SERVICE LETTER

No. 718

Piper Aircraft Corporation

Subject: Bendix Magneto Bulletin No. 566 -- reference attached Avco Lycoming Service Bulletin No. 373, dated March 22, 1974.

Figure 1.

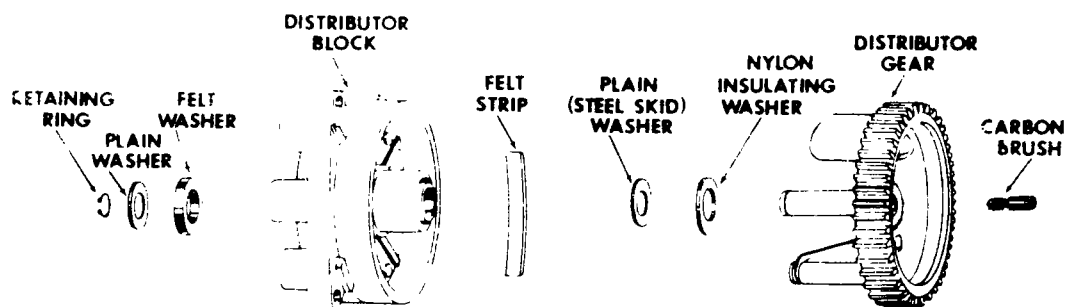
It has been found that the addition of a nylon insulating washer and steel skid washer between the distributor gear electrode and the block bushing, as shown in figure 1, reduces the possibility of deterioration of the lubricant and possible seizure of the parts.

Once modified, the distributor block can be used only with a gear having the nylon and steel washer installed over the shaft as shown in figure 1.

Assemble large distributor gear, nylon and steel washers to new or reworked block as follows using figure 1 as a guide.

2. Slide nylon insulating washer 10-391309 and plain washer 10-391511 onto gear shaft.

3. Lubricate inside of bronze bushing with a light film of Bendix Distributor Block Lubricant. ** Insert shaft of gear through distributor block and position plain washer on shaft. Using the 11-3071 Retaining Ring Pliers, install retaining ring on shaft. Rotate gear to insure there is no interference between gear electrode and block electrodes.

Figure 2

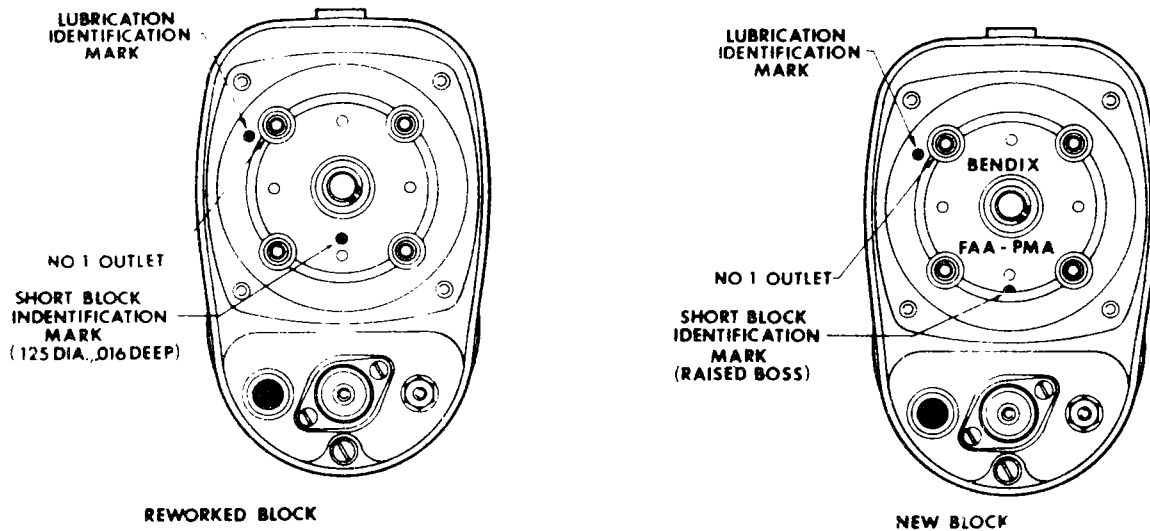
The addition of the washers make it necessary to shorten the gear end of the bushing and block. New production blocks incorporating the change are identified by a raised

boss between the high tension towers at the six o'clock position and molded in letters as shown in figure 2.

Reworked blocks are identified by a drill point indentation in the same location. New and reworked blocks both have different part numbers from the current (old) block. See Table 1.

7. Identify reworked blocks by drilling a flat bottomed hole .125" diameter and .016" deep in the six o'clock position as shown in figure 2.

(3) Identify distributor block by drilling flat bottomed indentation 0.125 inch diameter and 0.016 inch deep located as shown in figure 2.

Figure 3.

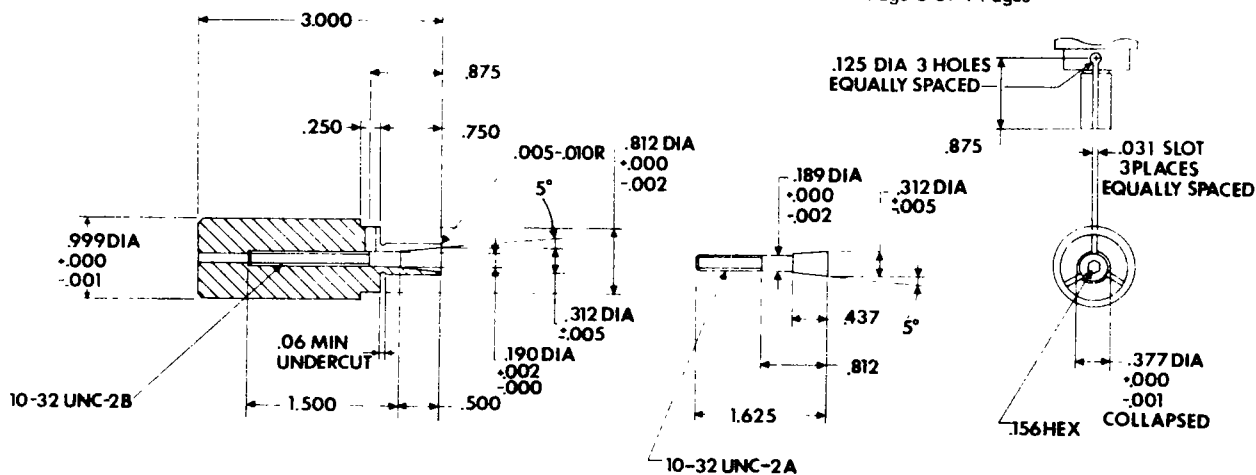
2. Fabricate an expanding arbor lathe fixture as shown in figure 3. (Similar arbors may be purchased from industry machine tool supply houses.)

3. With arbor in lathe, slide distributor block over arbor, high tension outlet tower side first, until block bushing bottoms on arbor shoulder. Tighten arbor expansion screw until block is held securely for turning operation.

Figure 4.

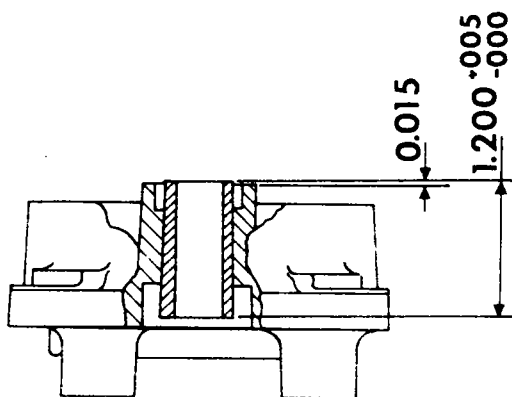
4. Use a suitable cutting tool and turn so that overall length of bushing is $1.200 \pm .005 - .000$ inch as shown in figure 4. (A Carbaloy tipped tool is recommended.)

5. Using same cutting tool, turn dielectric material of block so that resulting surface is .015 inch below end

of reworked bushing. See figure 4.
